Second Adequacy Review Response to Technical Revision TR-130

**RE: Permit No. M-1980-244; Cripple Creek & Victor Gold Mining Company; Cresson Project;
Second Adequacy Review Response to Technical Revision 130 – Stormwater Improvements**

WATERSHED BOUNDARIES

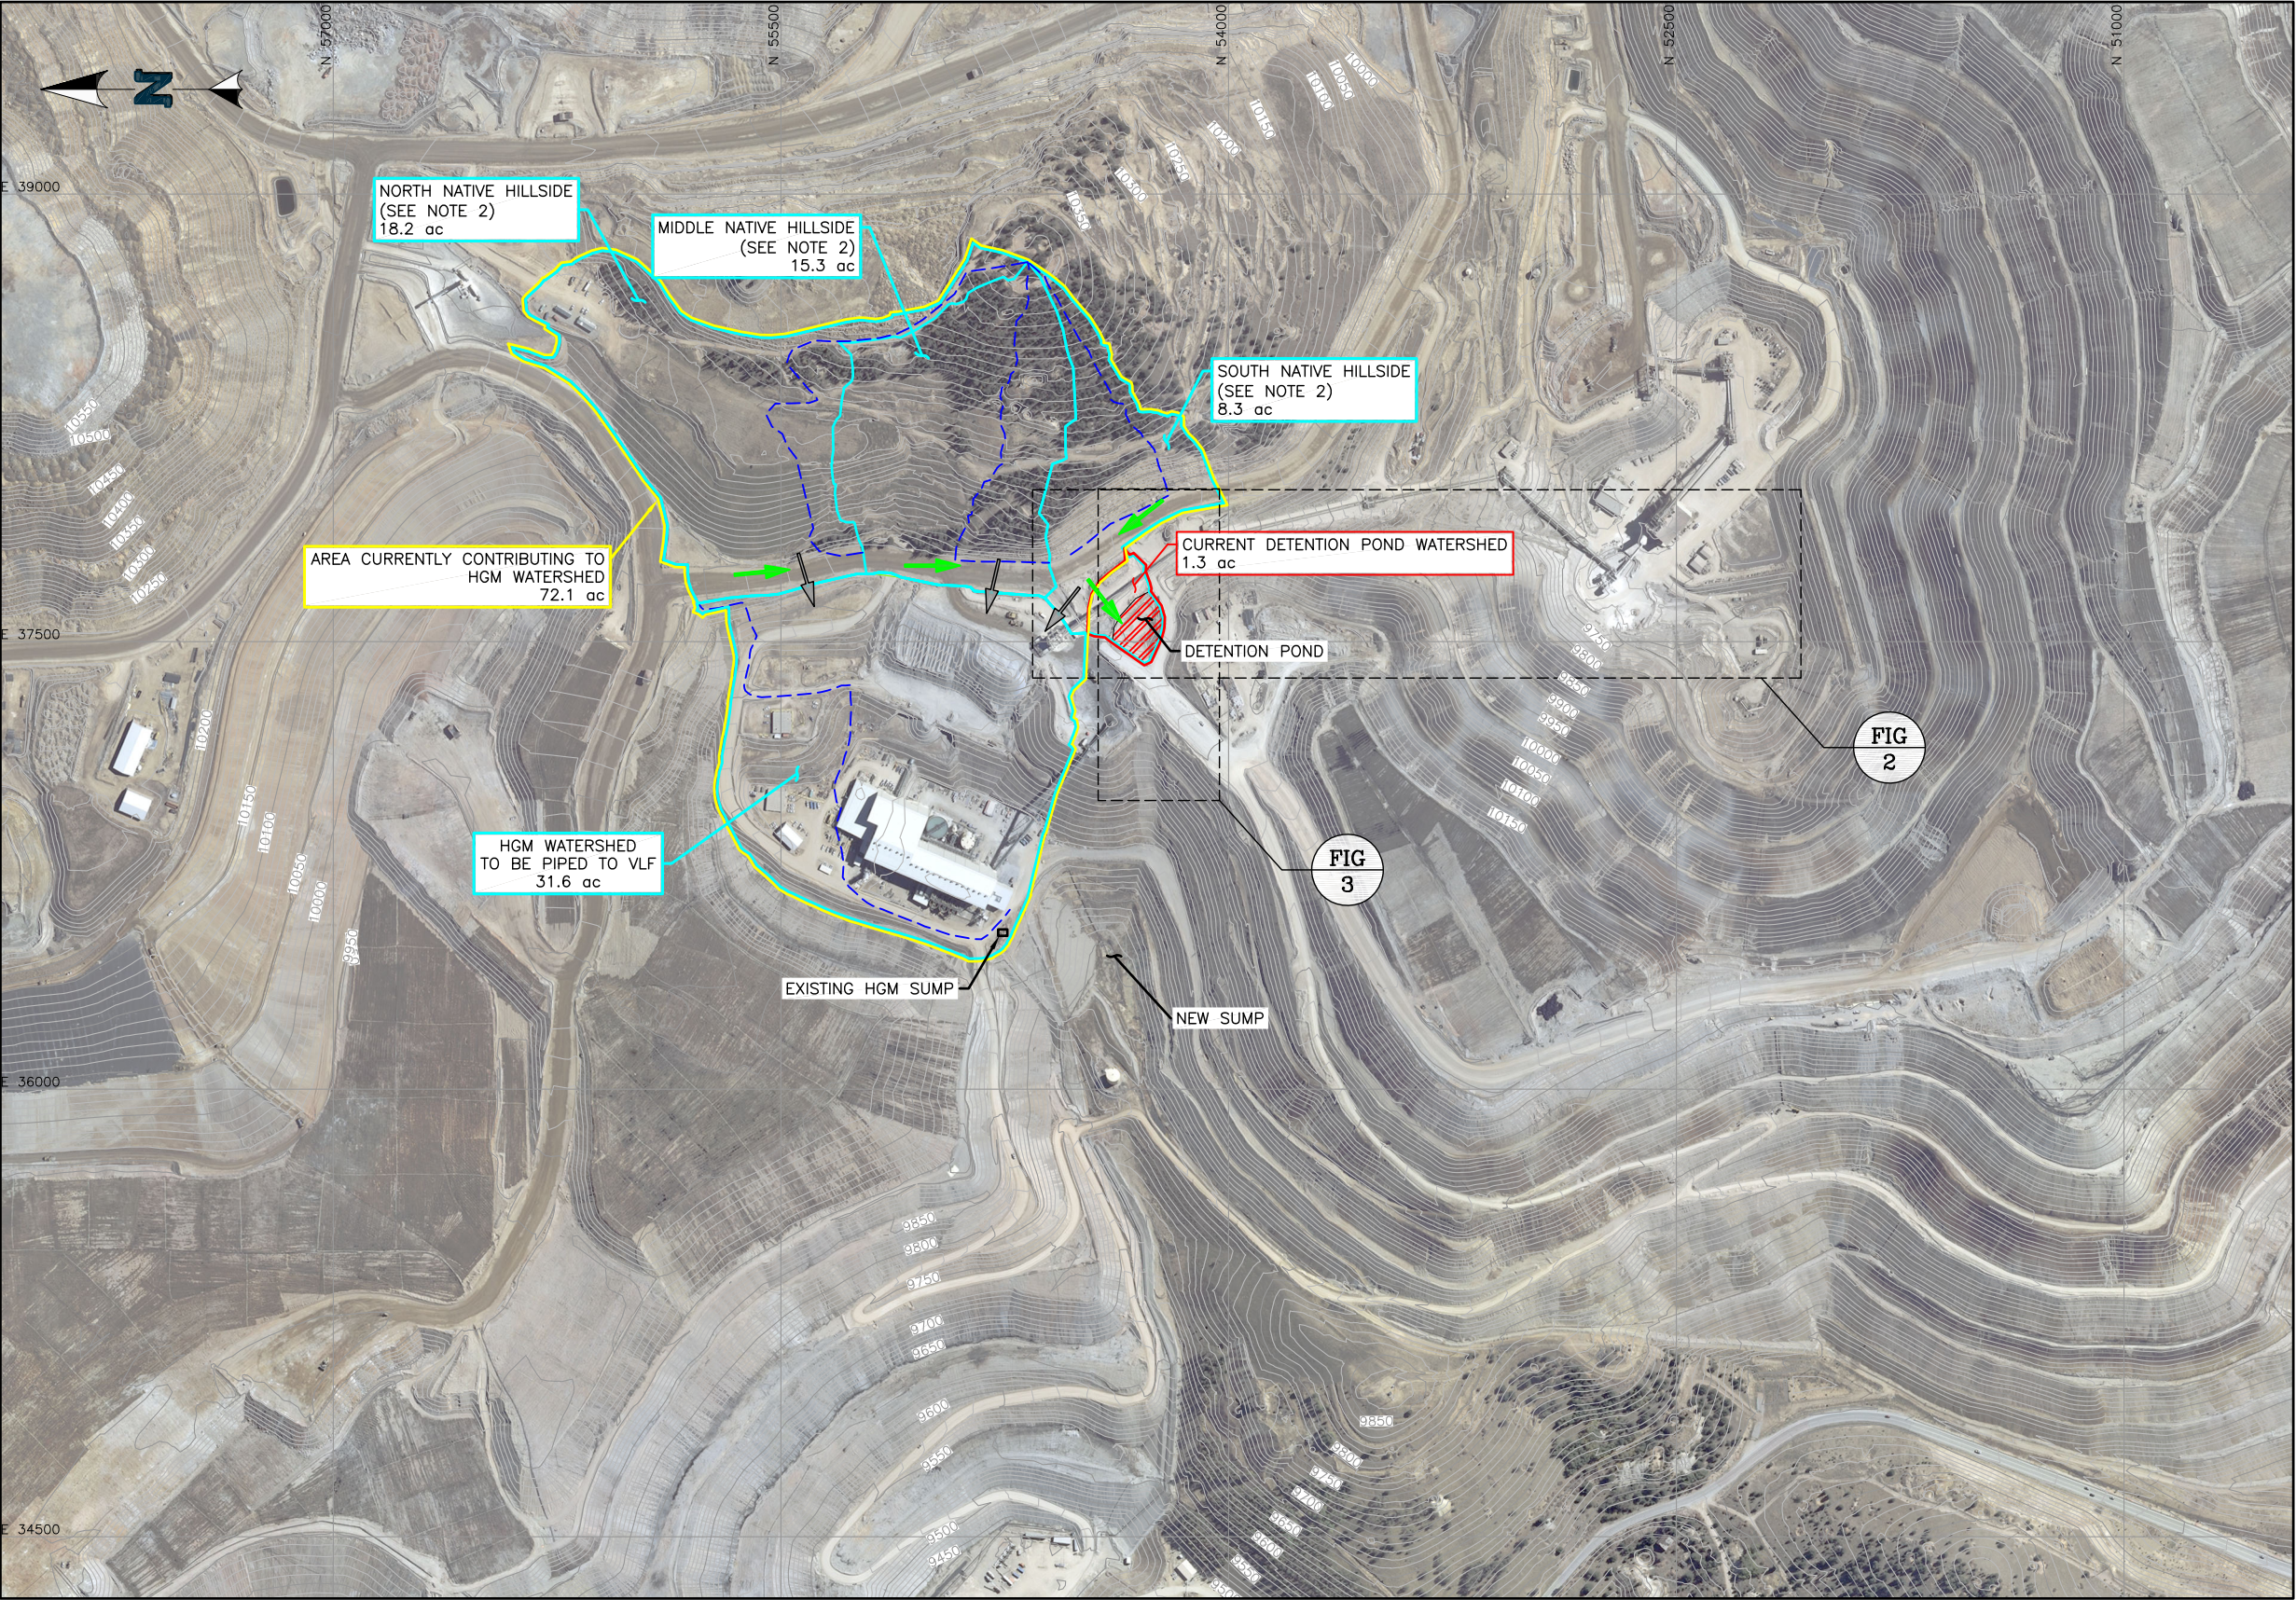
a. Figure 1, New Sump: The first paragraph of the response states both the HGM sump and "New Sump" are shown on Figure 1. There is a label for the "Existing HGM Sump", but not for the New Sump. Please provide a revised Figure 1 with the "New Sump" identified. **b. HGM Stormwater Storage:** The response indicates virtually all of the lined storage volume (4.66 ac-ft of the assumed 4.68 ac-ft) will be taken up with the storage of stormwater resulting from a 100-year, 24-hour design storm. The DRMS has three concerns with this approach: **i. Acid generating potential:** Due to the potential acid generating nature of the mill platform backfill material, the DRMS has been encouraging CC&V to keep the water level pumped down over the HGM liner. The use of this non EPF lined basin (without a leak detection system) is not ideal. What other alternatives were evaluated? [Note: this appears to be an appropriate time to remind CC&V that a closure plan for the HGM liner is needed. The DRMS cannot allow a non-free draining liner to store water in a potentially acid generating environment at mine closure.] **ii. Storage volume:** In the past, when the DRMS has inspected the existing HGM sump, there has typically been an estimated two feet of water in the sump. How does the assumed 4.68 ac-ft of storage account for the seemingly perpetual volume of water typically stored on the HGM liner, as observed in the existing sump? **iii. Foundation stability:** The proposed approach uses virtually all the available storage, thereby saturating an estimated five to seven feet of the backfill subgrade on which the HGM foundation was constructed. Based on the proposed 0.005 gpm/sqft application rate of the stored stormwater over 74,000 sq.ft., the DRMS estimates it will take roughly 4.7 days to

See revised Figure 1 indicating the location of the “New Sump”:
